DESIGN REVIEW - 1760 NW 56th STREET

1760 NW 56th St, Seattle, Washington  
DPD Project #3012436

BALLARD INVESTMENT PARTNERS, LLC  
ANKROM MOISAN ASSOCIATED ARCHITECTS  
June 05, 2012

# DESIGN GUIDANCE THEME 1: Massing and Shadow Study

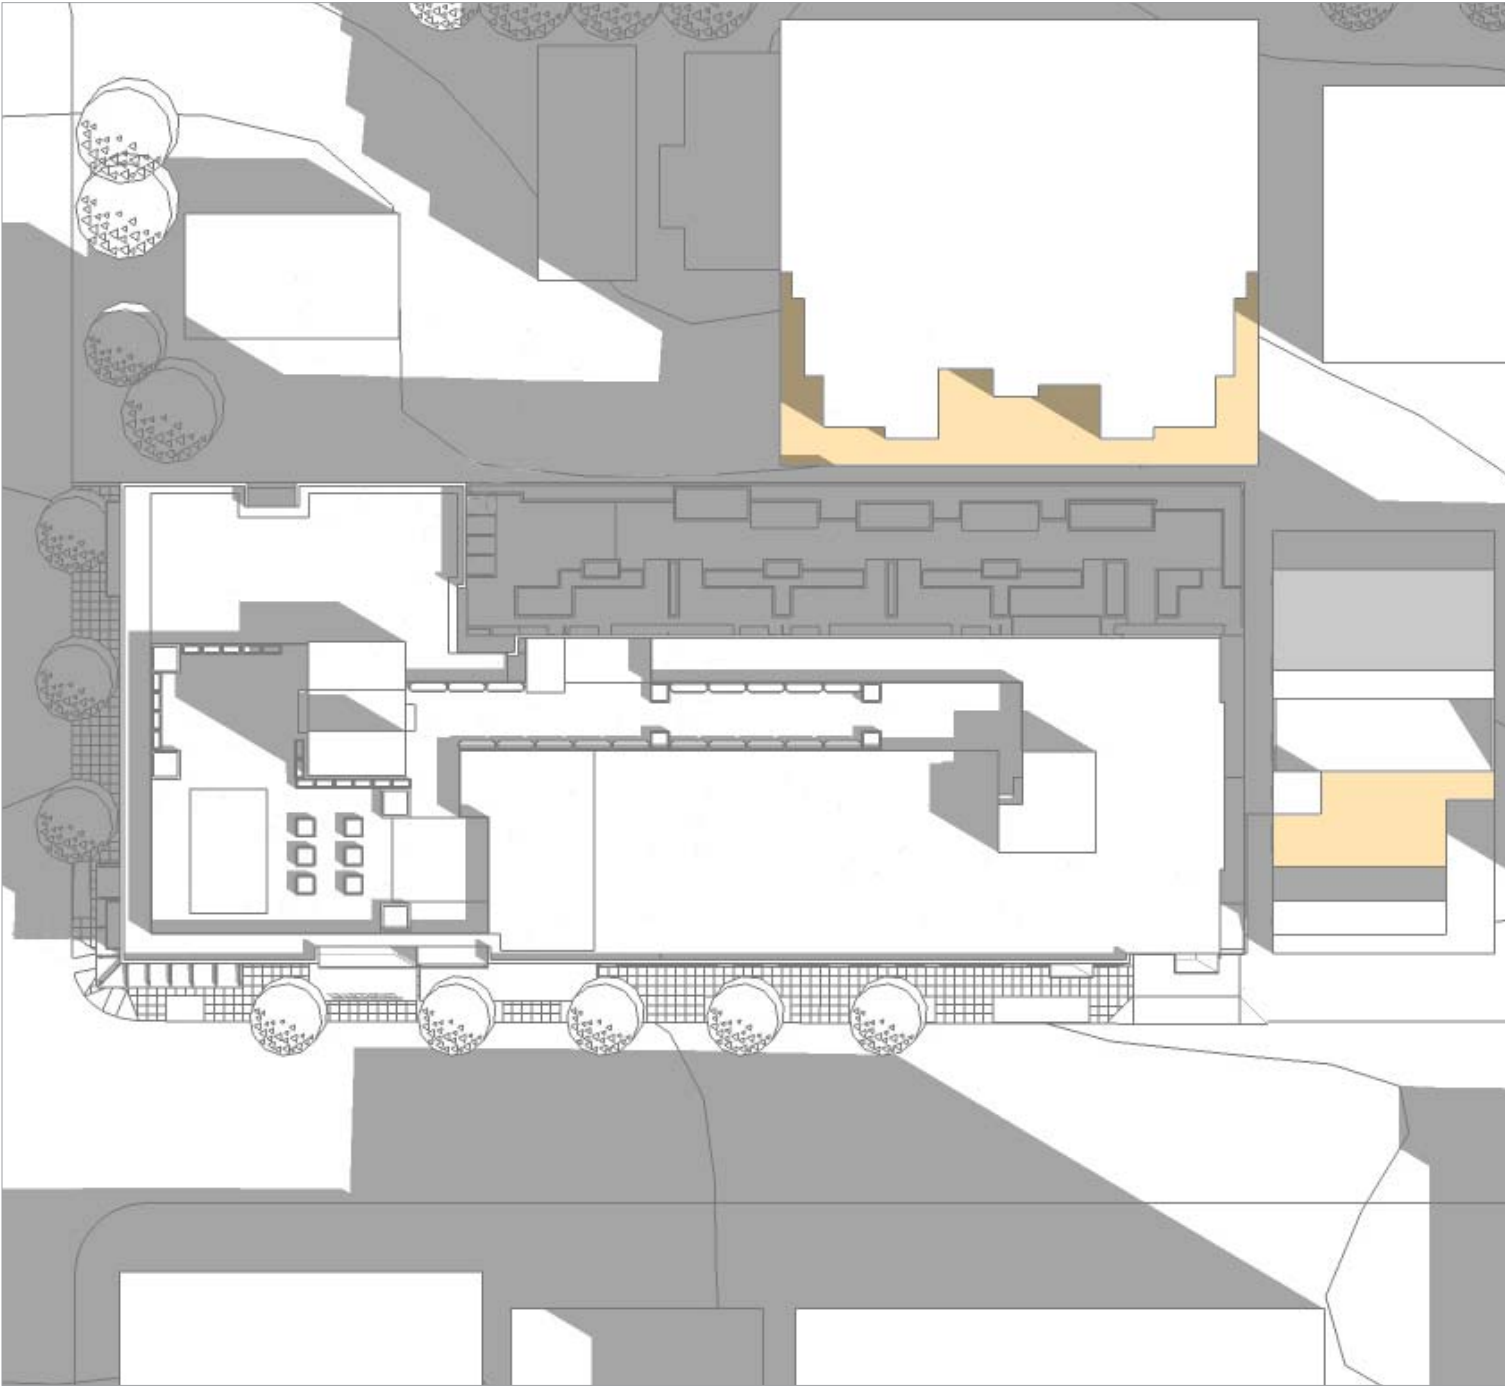
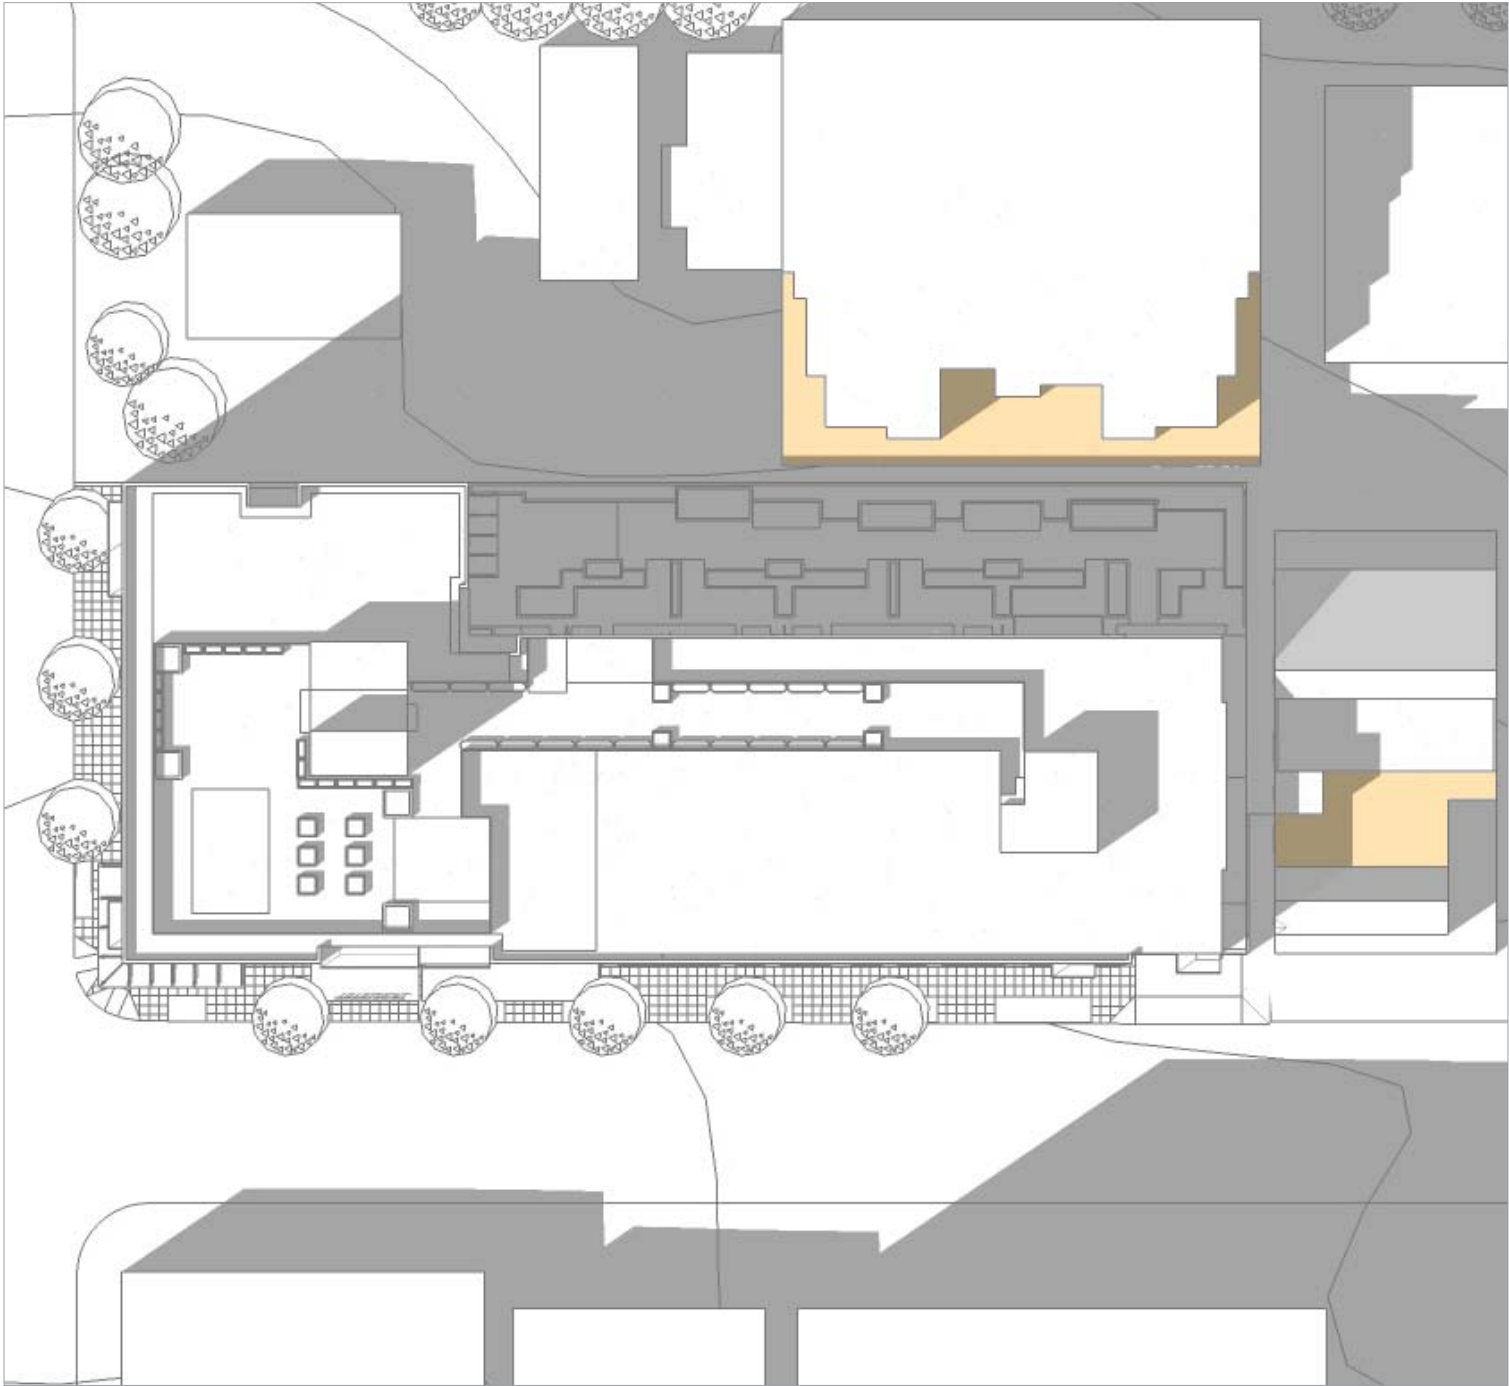
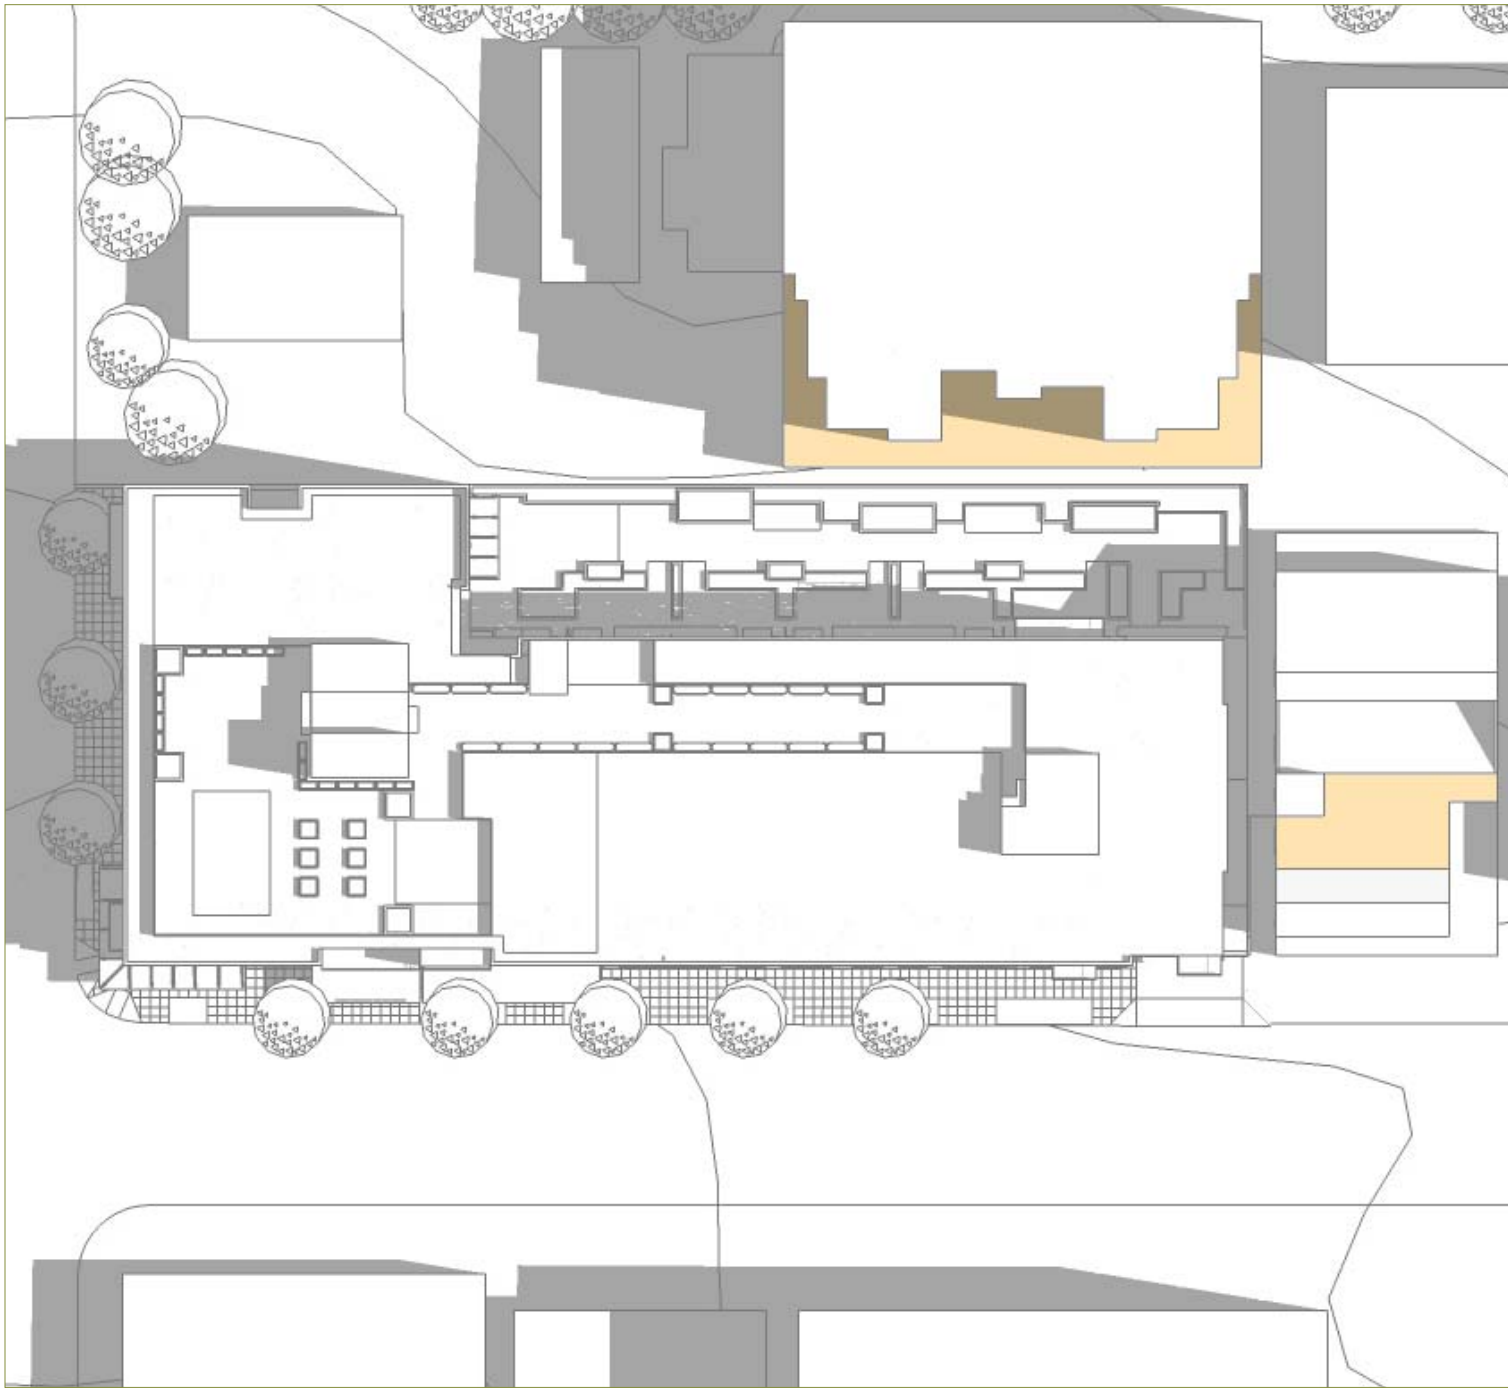
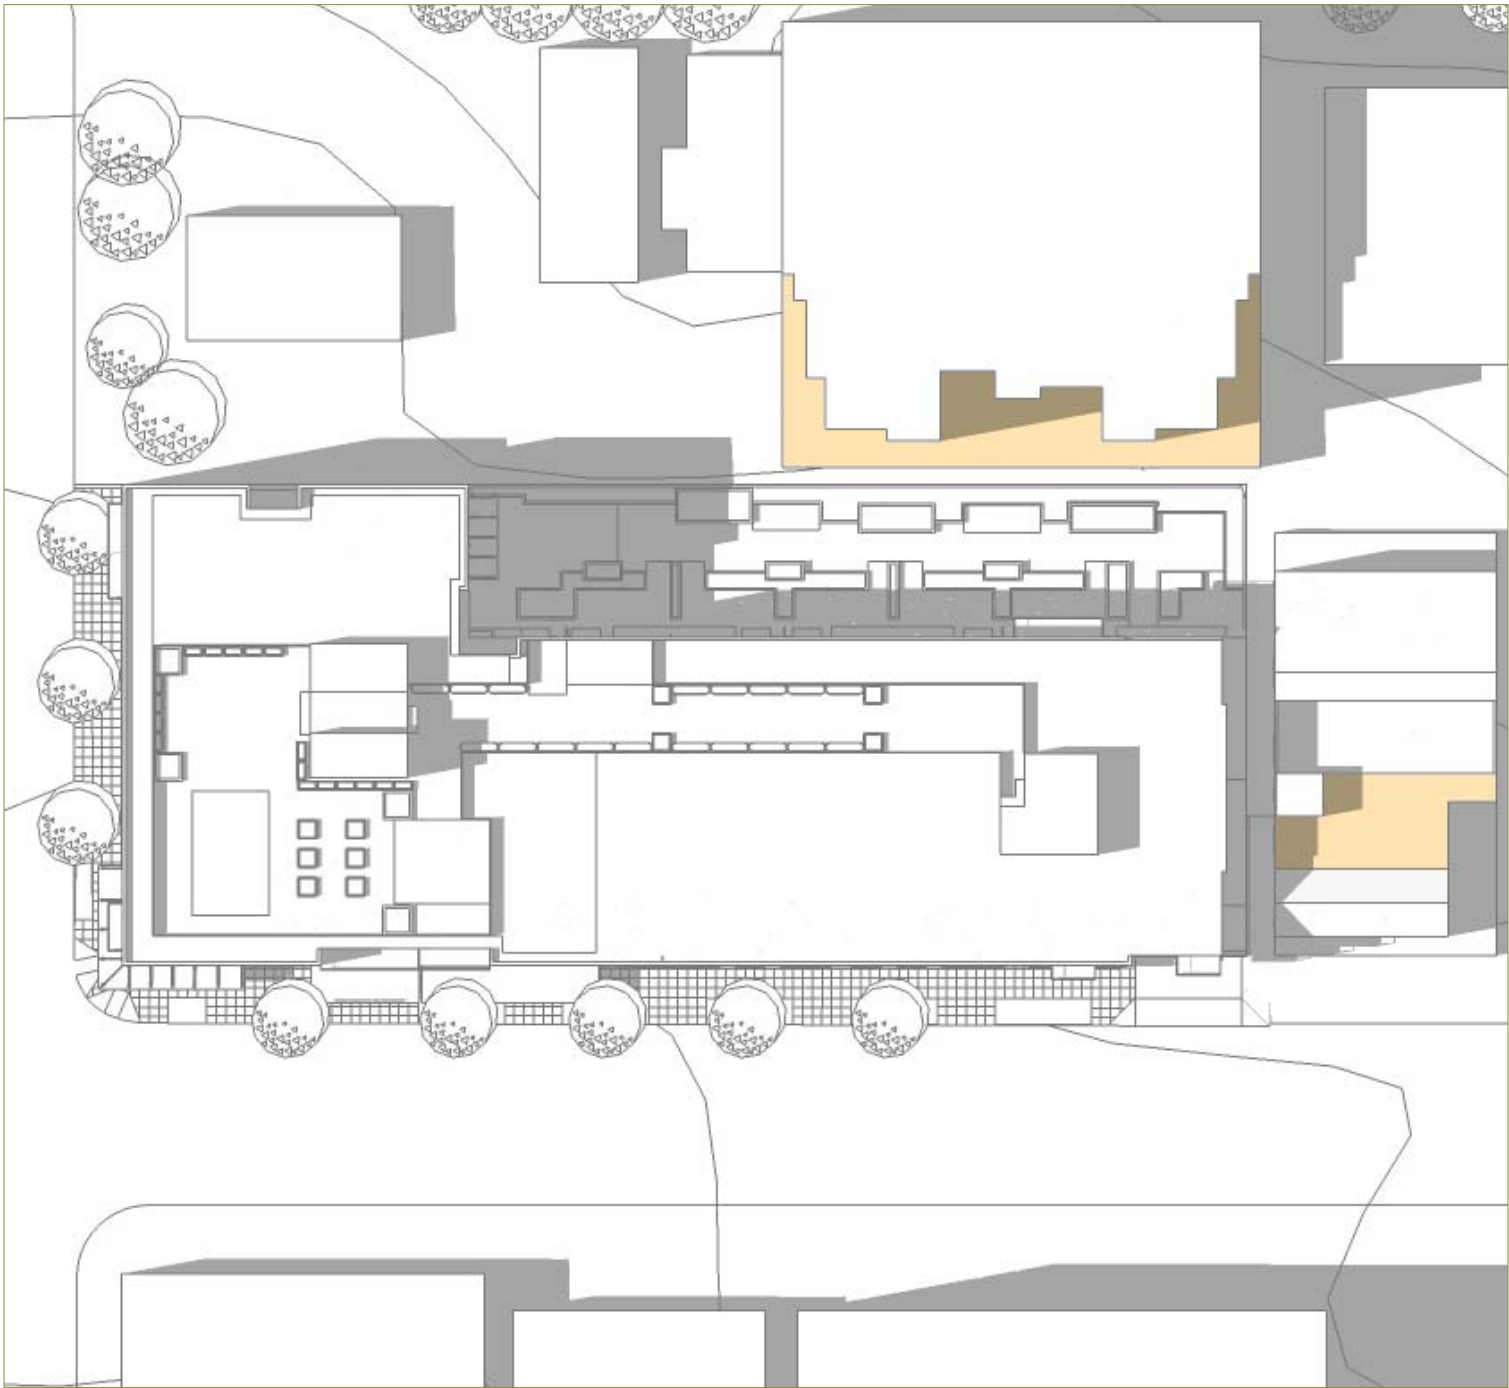
- " . . a solar/shadow study of the proposed building and how it affects both the neighboring buildings as well as the proposed courtyard open space."*
- " . . the relationship between the proposed building mass within the context of the surrounding building."*
- " . . warned against a monolithic expression along 56th street . ."*

SOLAR STUDY: SPRING/FALL
